SEWAGE DISPOSAL SYSTEM

MARYLAND STATE DEPARTMENT OF HEALTH

Alonso Powell IS PERMITTED TO INSTALL ☒ ALTER

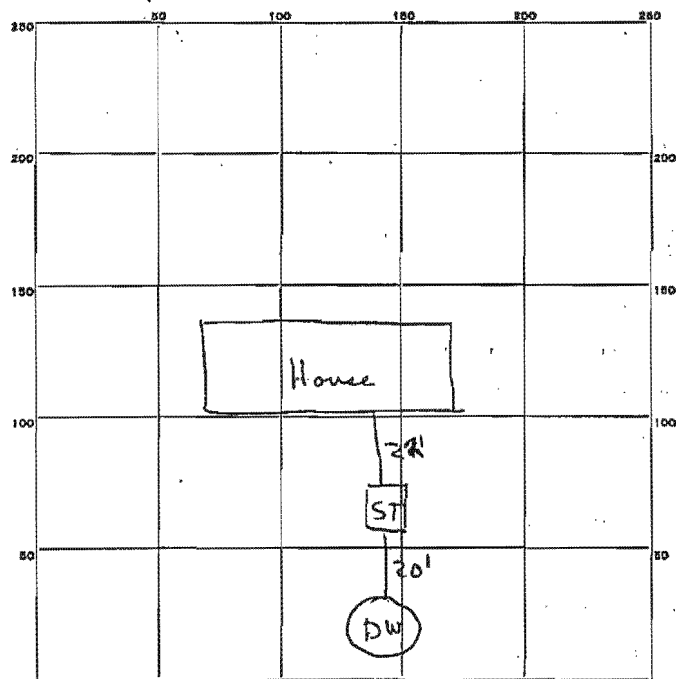
OTHER Dry well - 300 sq. ft. absorbent sidewall area to begin below the inlet pipe.
Place dry well in area that passed percolation test (about 63 ft. from front of House).

REMARKS 1/18/66 - Incomplete - gravel not around dugwell - P.F.

DATE SYSTEM APPROVED 1-28-66 INSPECTOR W. Manning
